New Milford

Route 7 (Danbury Road) – Road Safety Audit

July 27, 2016

Figure 8. Ramp at Dodd Rd. is not Connected to a Sidewalk.

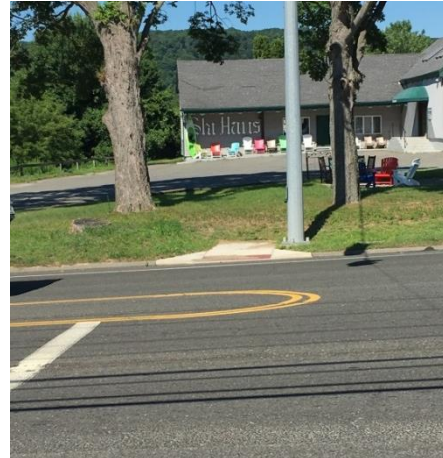
- On the southwestern side of this intersection, the crosswalk ramp is not connected to any sidewalks (Figure 8).
- Near the Walmart and Stop & Shop plaza intersection, the crosswalk ramps and detectable warning strips are situated at a 45° angle directing pedestrians diagonally into the intersection.

Figure 12. Intersections do not have Painted Crosswalks

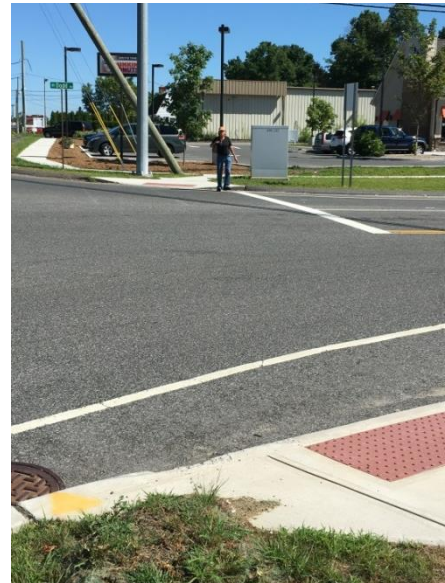
1. Many of the concerns and challenges identified are consistent along all of Route 7 through the Town, and are not isolated to the RSA corridor between Still River Drive and Dodd Road. Any improvements proposed in the RSA area should also be considered north of the RSA area, between Dodd Road and Bridge Street.
2. Many intersections are not ADA compliant. There have been some upgrades, but these facilities are not consistent through the corridor.
3. There are no painted crosswalks crossing Route 7 (Figure 12). As a result, this may encourage pedestrians to cross mid-block as was observed during the field audit.

Figure 17. Short Term Recommendations

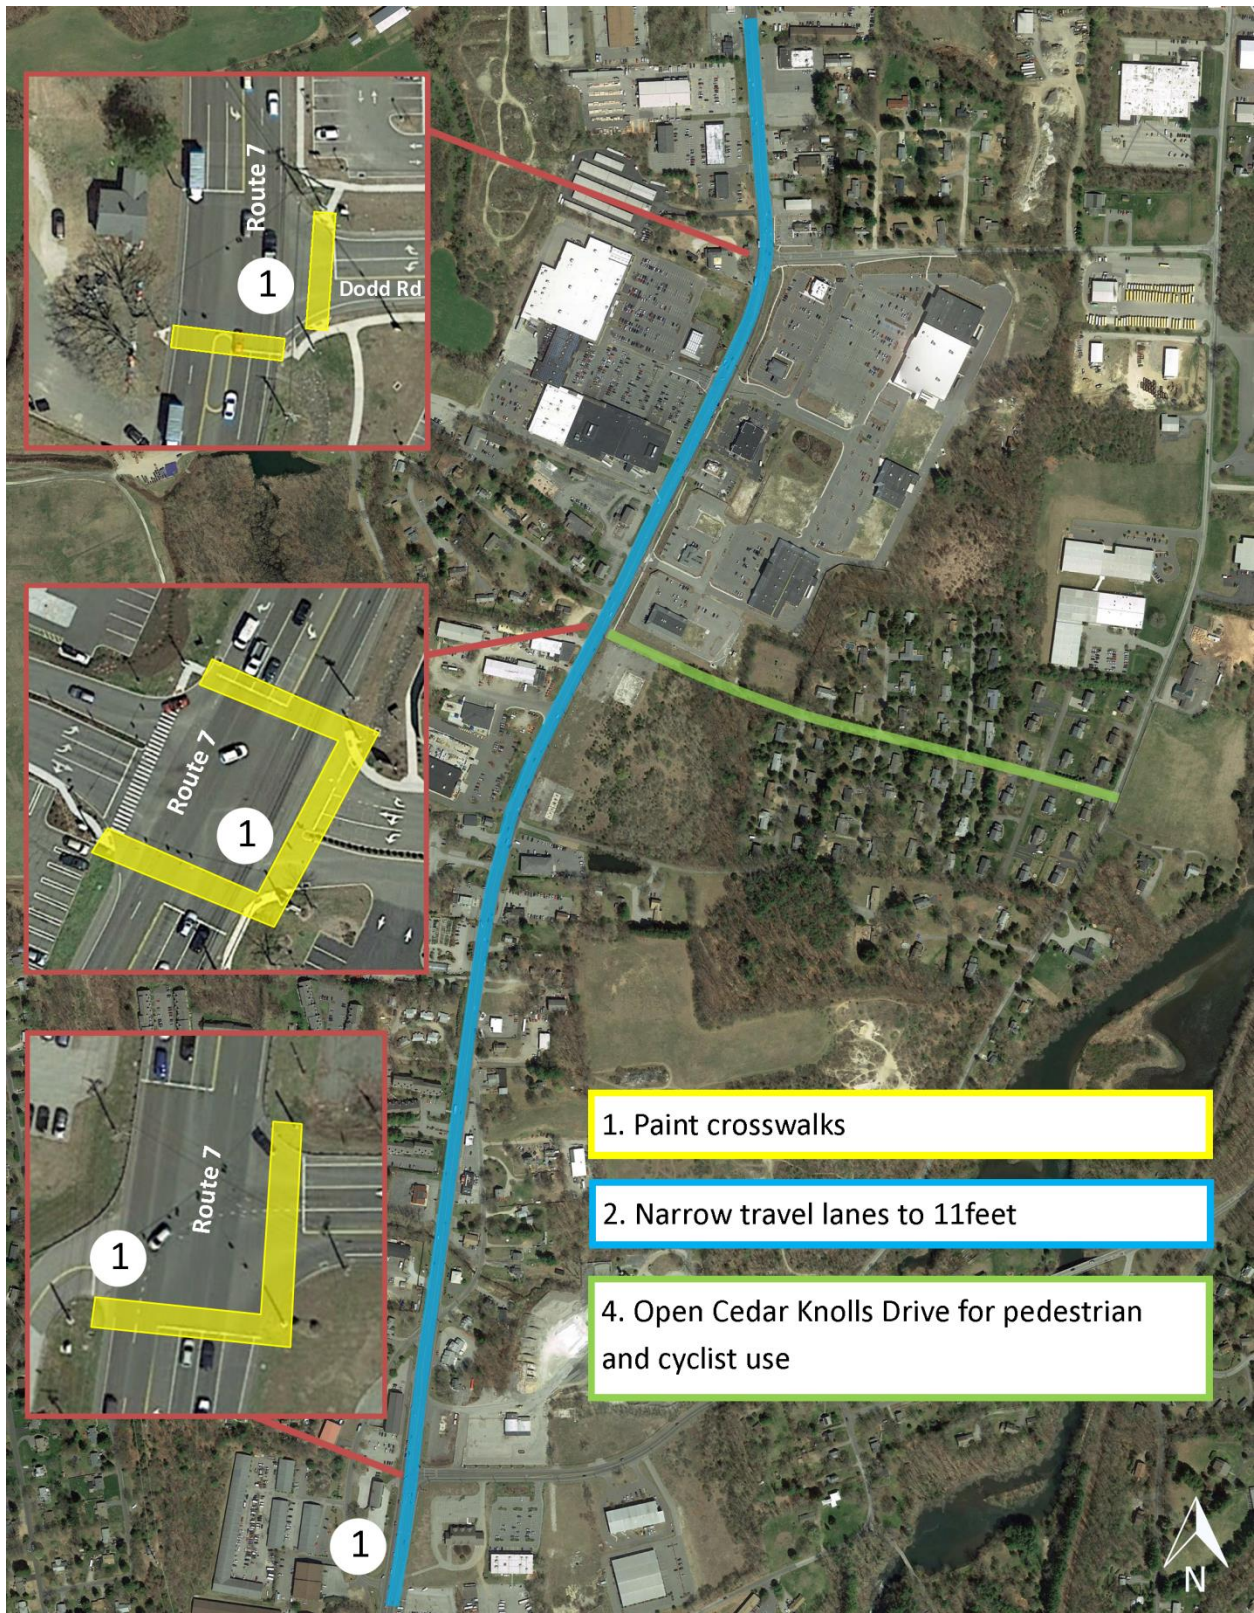
1. The Local Traffic Authority (LTA) should submit a letter of request to CTDOT to paint crosswalks at the following intersections:
 - a. Dodd Road.
 - b. Walmart and Stop & Shop plaza (Figure 15).
 - c. Still River Drive.
- 2) Coordinate with CTDOT Maintenance District to find out when Route 7 is being repaved.
 - a. When Route 7 is repaved, request that lanes are narrowed to 11 feet.
- 3) LTA should request pedestrian counts to be conducted on Route 7.
- 4) Investigate feasibility of opening up Cedar Knolls Drive for recreational use (bikes and pedestrians) (Figure 16).
- 5) Review and update town plans, such as the Plan of Conservation and Development and Access Management Plan.
- 6) Map existing sidewalks on Route 7 to identify areas to expand and/or connect existing sidewalks.

Figure 19. Develop Sidewalk Plan

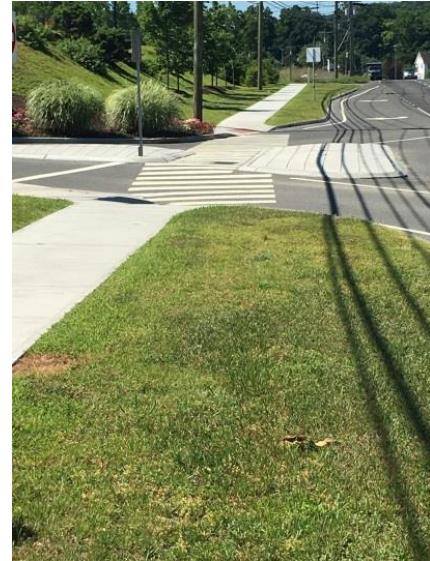
1. LTA should request upgrades to intersections to include:
 - a. ADA compliant ramps with detectable warning strips.
 - b. ADA compliant pedestrian crosswalk signals.
 - c. ADA compliant pushbuttons (Figure 18).
2. Develop a sidewalk plan to expand the network of sidewalks on Route 7 (Figure 19).

Figure 22. Long Term Recommendations

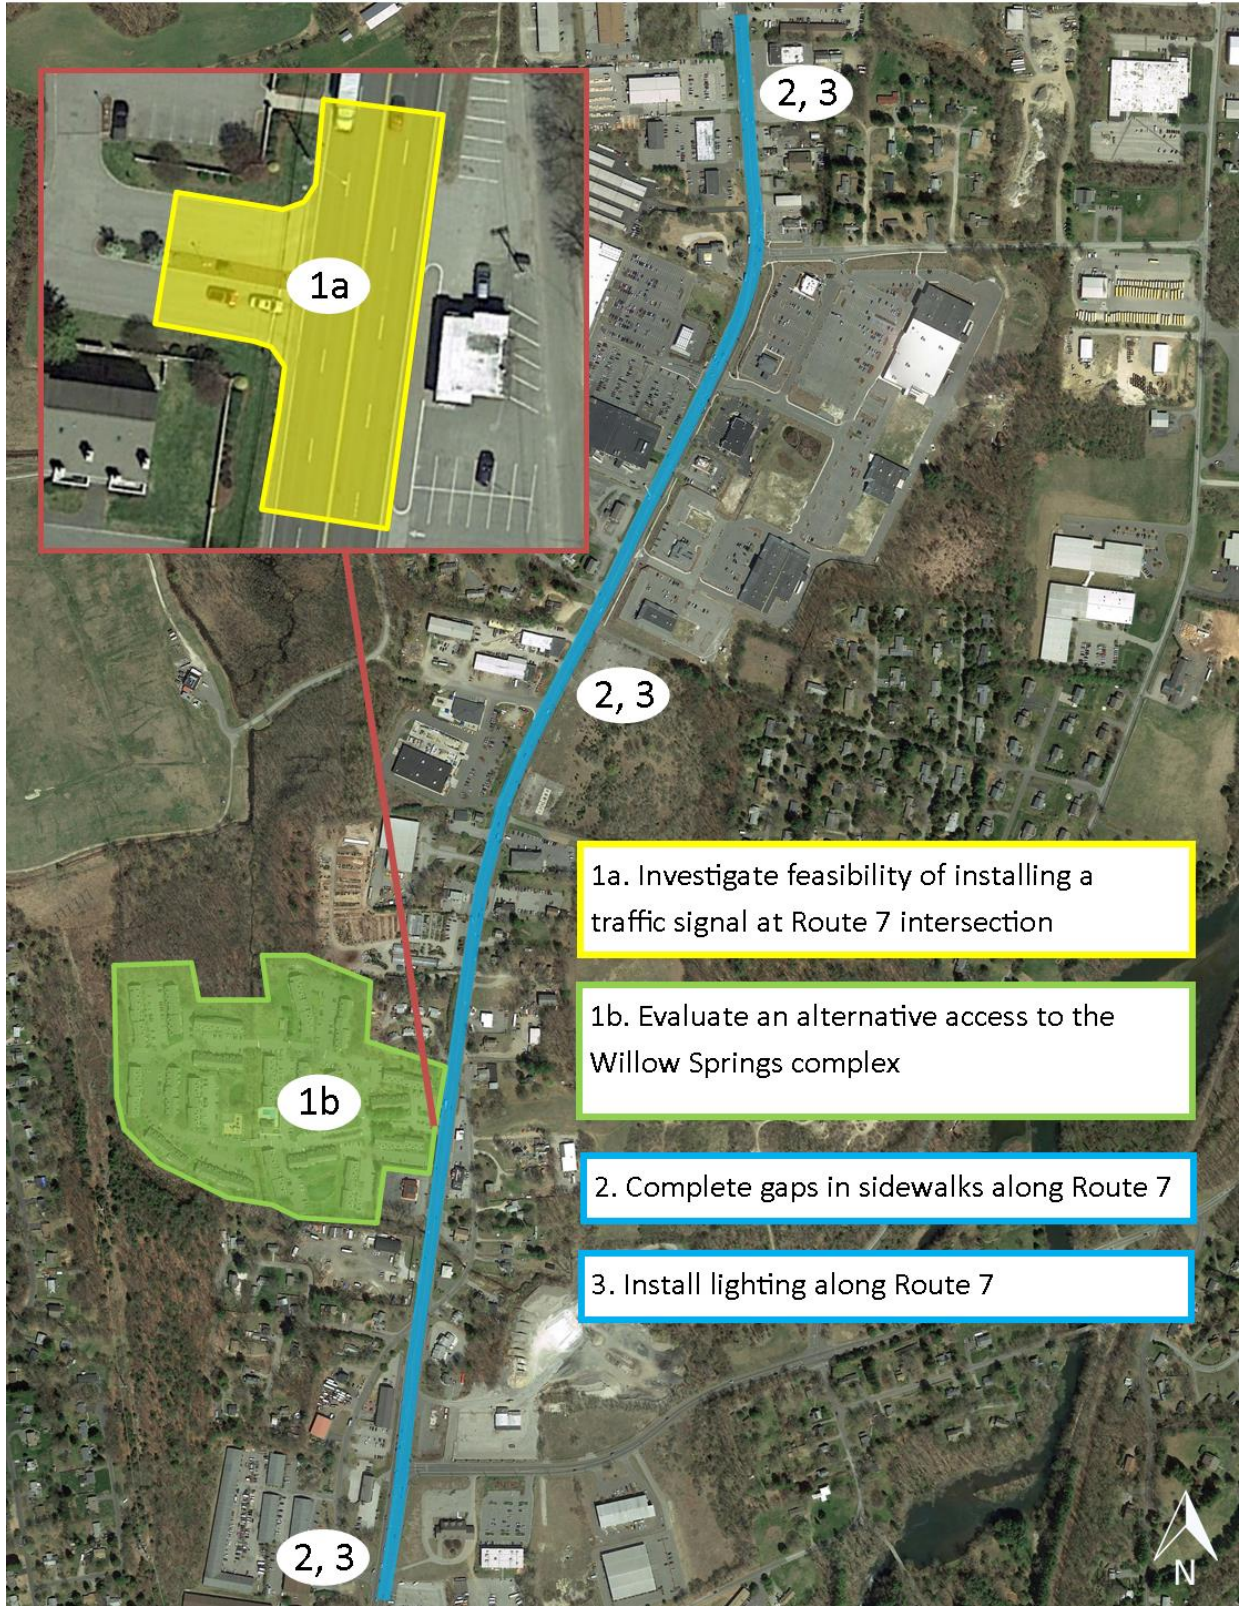
1. Evaluate access to Willow Spring condominium complex:
 - a. Investigate feasibility of installing traffic signal at the Route 7 intersection.
 - b. Evaluate feasibility of providing an alternative access to the development.
2. Where possible, construct sidewalks to complete gaps along Route 7 (Figure 21).
3. Install lighting along Route 7 to improve visibility at night.
